Detailed Site Plan Hillside at Fort Washington

DSP-22022

STAFF REPORT

SUBJECT: Detailed Site Plan DSP-22022
Type 2 Tree Conservation Plan TCP2-005-2023
Hillside at Fort Washington

Figure 4. Entrance monument

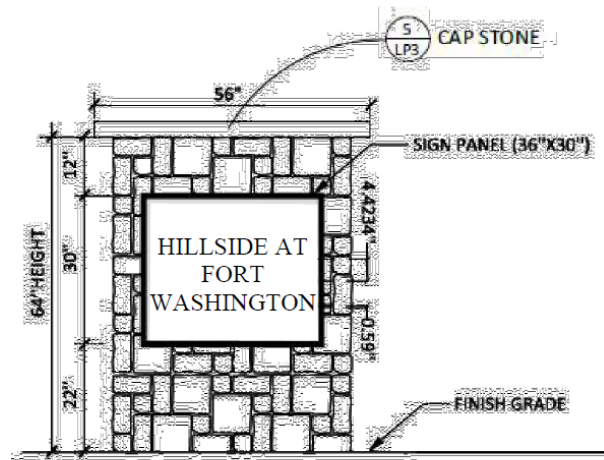
A stone monument sign is proposed at the entrance to the community. The sign will measure approximately 64-inches-high and 56 inches wide and will be faced with an ashlar stone pattern and capped with Indiana Limestone. The sign panel will be 36 inches by 30 inches and set into the stone facing. The plan detail does not indicate if any form of illumination will be provided, so a condition has been included herein, to provide the method of lighting, if any, in the detail.

- e. Provide the method of illumination, if any, on the entrance sign detail.
 - f. Provide a trash receptacle in the playground area and a detail on the plan.
